APPLICATION FOR PERMIT TO DRILL		1. WELL NAME and NUMBER GMBU 125-36-8-16
2. TYPE OF WORK DRILL NEW WELL <input checked="" type="checkbox"/> REENTER P&A WELL <input type="checkbox"/> DEEPEN WELL <input type="checkbox"/>		3. FIELD OR WILDCAT MONUMENT BUTTE

NEWFIELD PRODUCTION COMPANY
 GMBU 125-36-8-16
 AT SURFACE: SE/SE SECTION 36, T8S R16E
 DUCHESNE COUNTY, UTAH

TEN POINT DRILLING PROGRAM

Pad Location: SESE Section 36, T8S, R16E, S.L.B.&M.

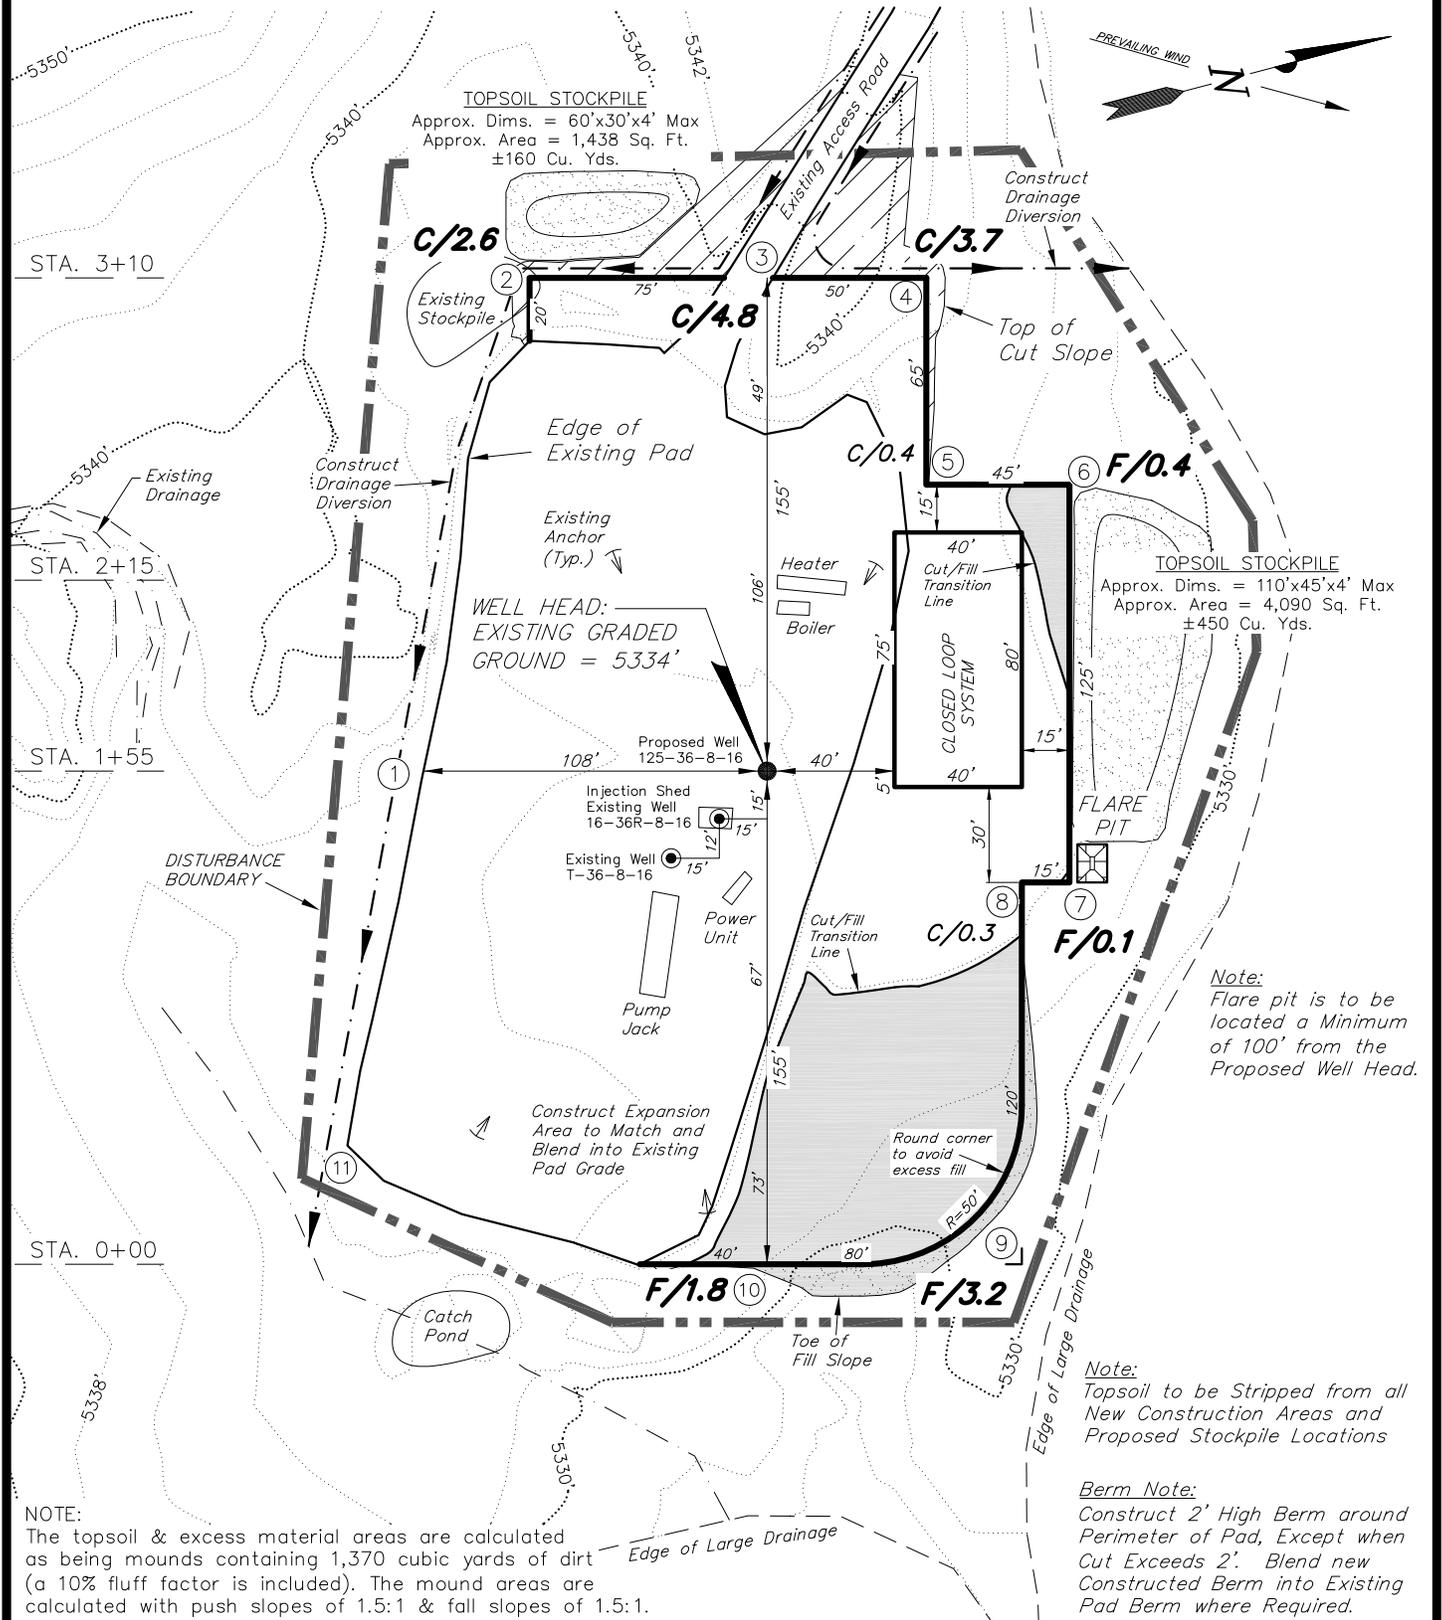
Reserve pit planned but I think a closed loop system is warranted due to proximity to stream. Other wells upstream in this feature were drilled recently closed loop

This location needs a lot of work. The access road is planned to be lowered. This will make diversion off to the sides impossible and will funnel flows onto the pad. This pad is already flooded most of the year. The heavy clays retard the infiltration of any water. I have been stuck in 4wd on this location in the past. The north side of the road will need to be removed so that it is not higher than the road and flows can escape back into the stream. The south will need to be left high to divert flows from the hillside from entering road and divert flows from the west. The topsoil pile will need to be moved as it is being washed away in its current location. I think a closed loop system is wise here as reserve pit is planned adjacent the stream and there are drainages opposite. I have stability concerns because of the heavy clays. This location SCREAMS for gravels to be imported and location capped for stability, safety and flooding. In a perfect world, I would like to see provisions for the water crossings.

Usual construction standards of the Operator do not appear to be adequate for the proposed purpose as submitted. Plans lack measures for importing materials, using a geogrid or compacting native soils to improve stability. Existing topsoil stockpiles are in danger of erosion.

Casing Schematic

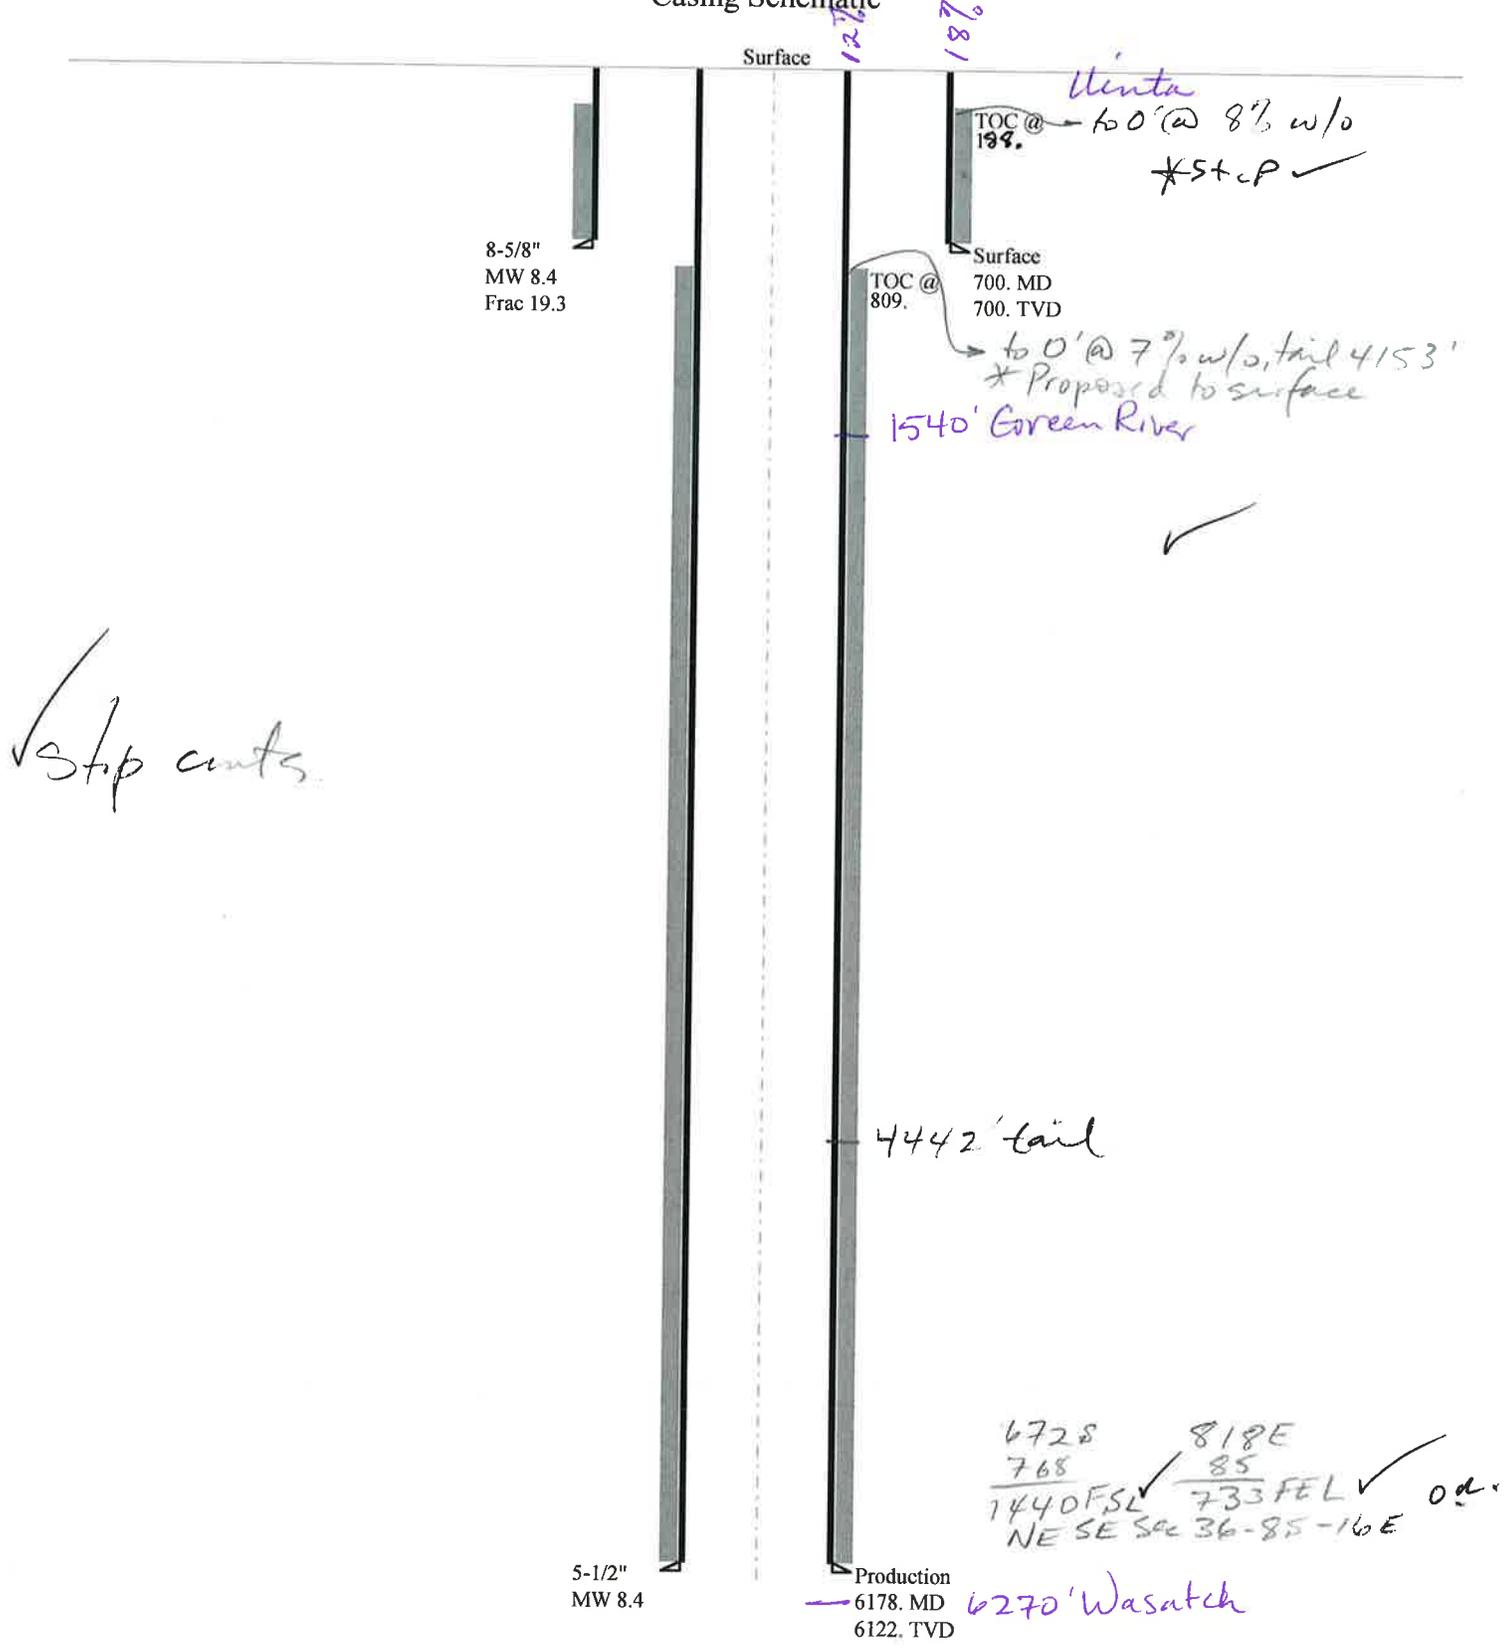
Cement volume for the 5 1/2" production string shall be determined from actual hole diameter in order to place cement from the pipe setting depth back to surface as indicated in the submitted drilling plan.
